**Environmental
Planning
Commission**

Staff Report

Agenda Item Number: 2
Project #: PR-2023-009363
**Case #: SI-2023-01635/
SI-2023-01638**
Hearing Date: November 16, 2023

Agent	Consensus Planning
Applicant	City of Albuquerque Parks and Recreation Department/New Mexico United Soccer
Request	Major Amendment of a Master Development Plan/Site Plan for Subdivision Site Plan-EPC
Legal Description	All or a portion of Tracts A-1 through G-1, Plat of Tracts A-1 through H-1, I-1-A & I-2-A, Tract I-A-A, Plat of Tracts A-1 through H-1, I-1A & I-2-A, and a fraction of Lot 2, located in NE ¼ NE ¼ Sec 11, T11N, R3E, a/k/a Tracts F & G, Heirs of Filiberto Gurule Tract
Location	Balloon Fiesta, Park, between Paseo del Norte NE and Roy Avenue NE
Size	Approximately 7-acre portion of 367.5 acre site
Zoning	NR-PO-A

SHEET 1 OF 11
 NOV. 05, 2023

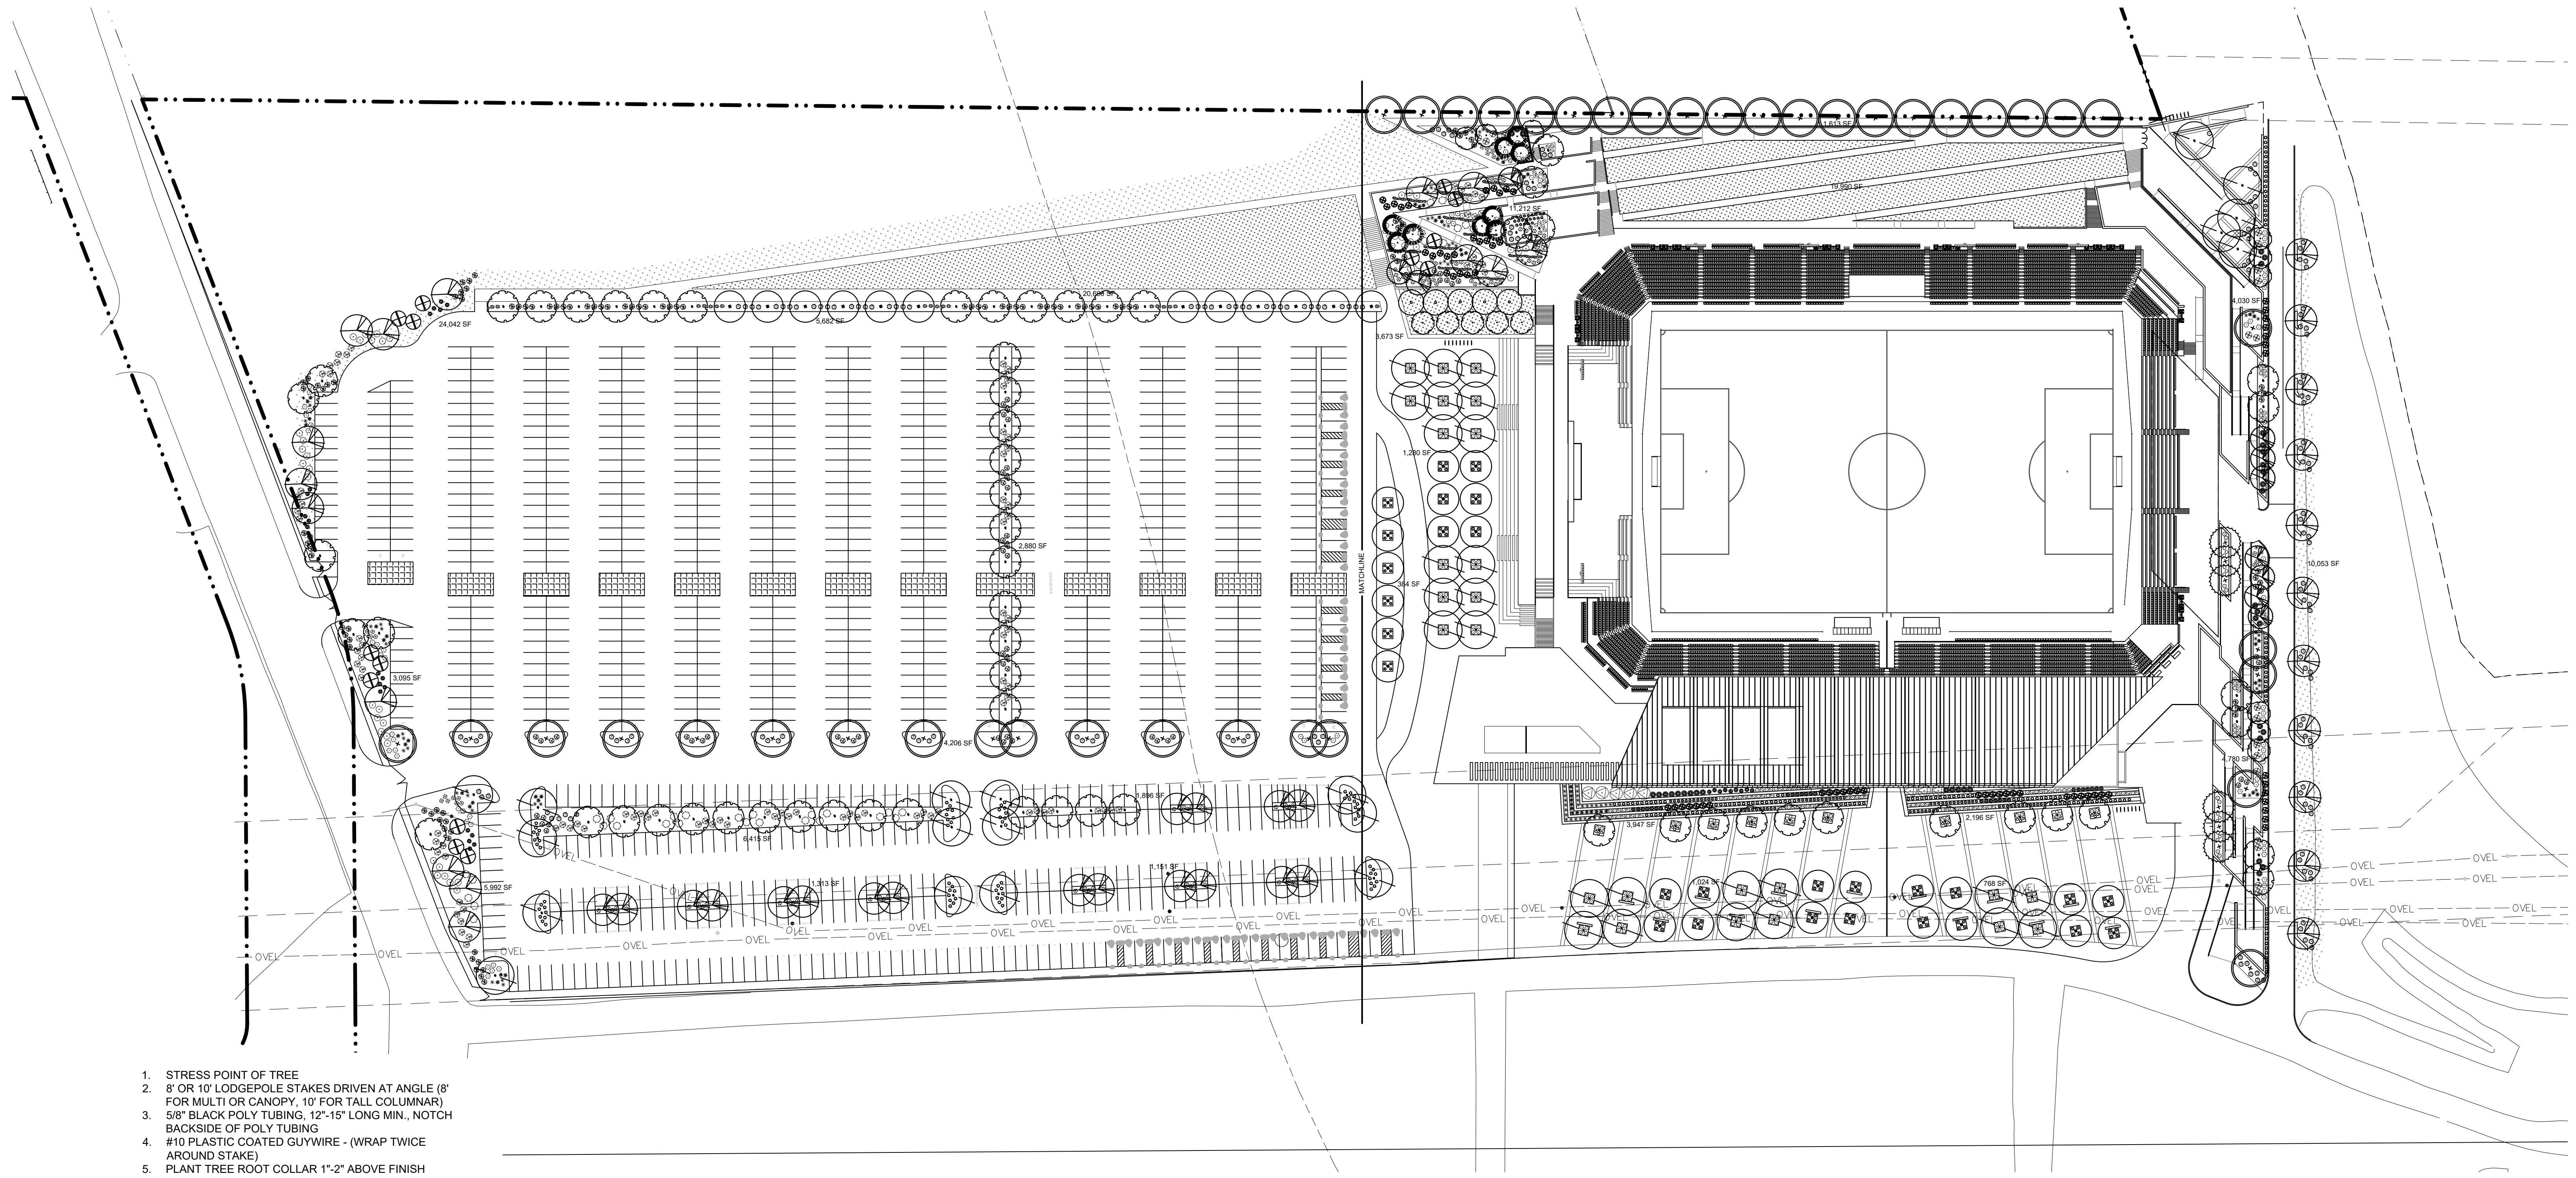
An inconsistency has been identified on the Site Plan (Sheet 1), where it indicates 1,209 parking spaces, whereas the parking calculation table on the East Lot lists 1,175 parking spaces. To address this, a condition of approval will be incorporated.

An inconsistency has been identified on the Site Plan (Sheet 1) and the Landscape Plan. To address this, a condition of approval will be incorporated.

Sheet 1 – Site Plan (*Details needed*)

5. Landscaping, Buffering & Screening
 - A. The Overall Landscape Plan shall be revised to correspond with the Site Plan parking calculations (Sheet 2).

2. Vehicular Access Gate
A typical vehicular access gate detail has been added on the new Architectural Details, Sheet 11.
3. Pedestrian Access Gate
A typical pedestrian gate detail has been added on new Architectural Details, Sheet 11.
6. Refuse Enclosure and containers per within walled/fenced service yard.
The refuse enclosure was removed from the project. A trash compactor and recycling compactor will be provided within the loading bay inside of the stadium.

2 EAST ELEVATION
1" = 20'-0"

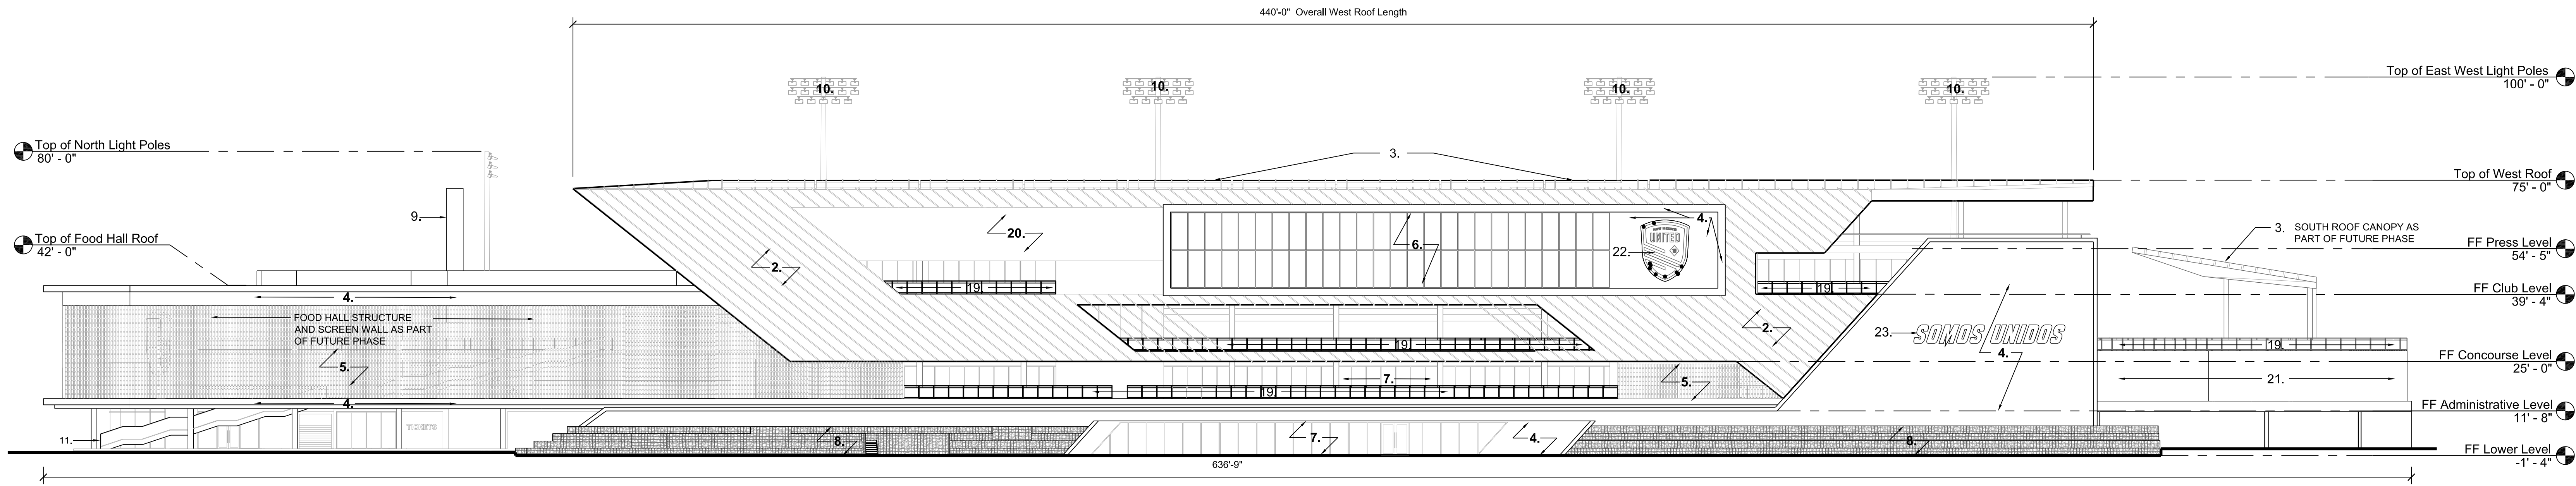
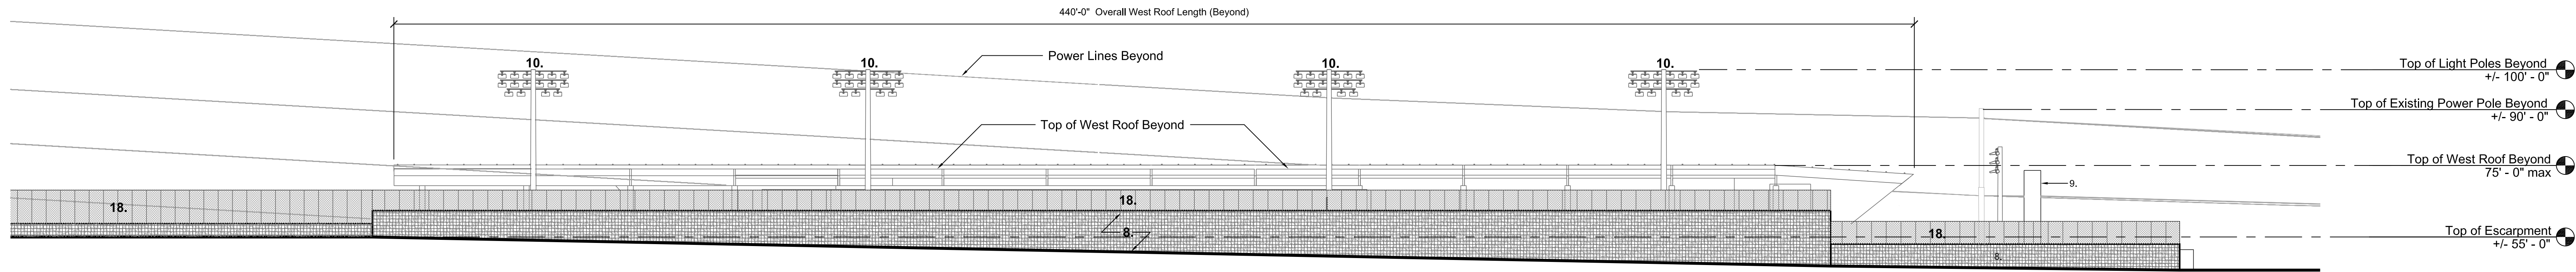
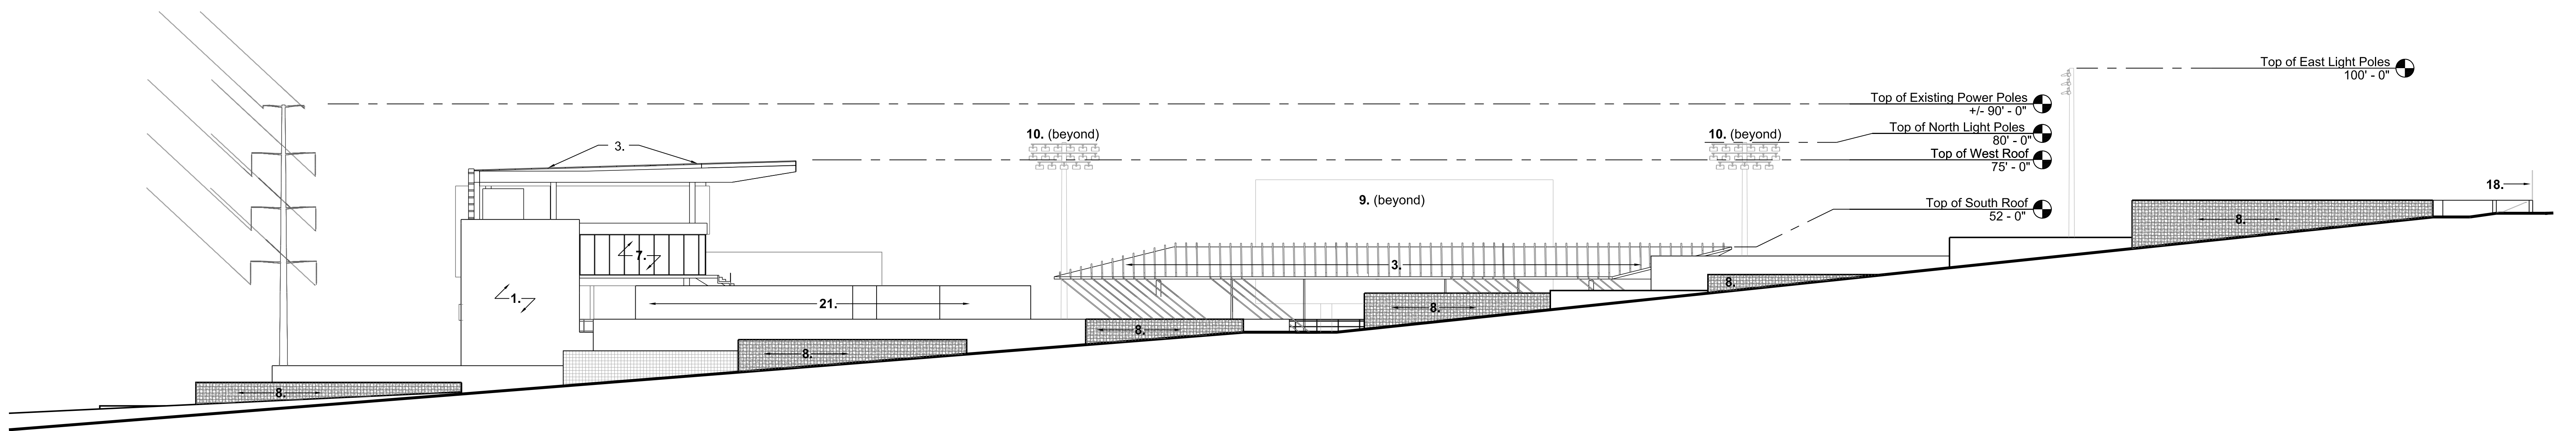
The south roof canopy and food hall will be constructed as part of a future phase based on availability of funding. The future phase Food Hall is 33,000 SF, which is included within the overall building area of 185,500 SF listed on Sheet 1. General Notes have been added to Sheet 1 to explain phasing and annotations indicating phasing of food hall and south roof canopy have been added to the Sheet 1 Site Plan and Sheet 9 and Sheet 10 Elevations.

Sheet 9 – Building and Structure Elevations

10. Light poles
A light pole detail has been added on new Architectural Details, Sheet 11.
11. Monumental Stair/Steel Structure
A monumental stair detail has been added provided on new Architectural Details, Sheet 11.
15. Pedestrian Concourse Bridge (if available)
A Concourse Bridge / Typ. guardrail system detail has been added on new Architectural Details, Sheet 11.
16. Vehicular Gate
This note was not used - see typical vehicular access gate detail.
18. Perimeter Fence, Heavy-Duty Wire Mesh and Perforated Panels
A typical perimeter fence detail has been added on new Architectural Details, Sheet 11.

The original submittal did not indicate phasing, which was an oversight. The south roof canopy and food hall will be constructed as part of a future phase based on availability of funding. The future phase Food Hall is 33,000 SF, which is included within the overall building area of 185,500 SF listed on Sheet 1. General Note I has been added to Sheet 1 to explain phasing and annotations indicating phasing of food hall and south roof canopy have been added to the Sheet 1 Site Plan and Sheet 9 and Sheet 10 Elevations.
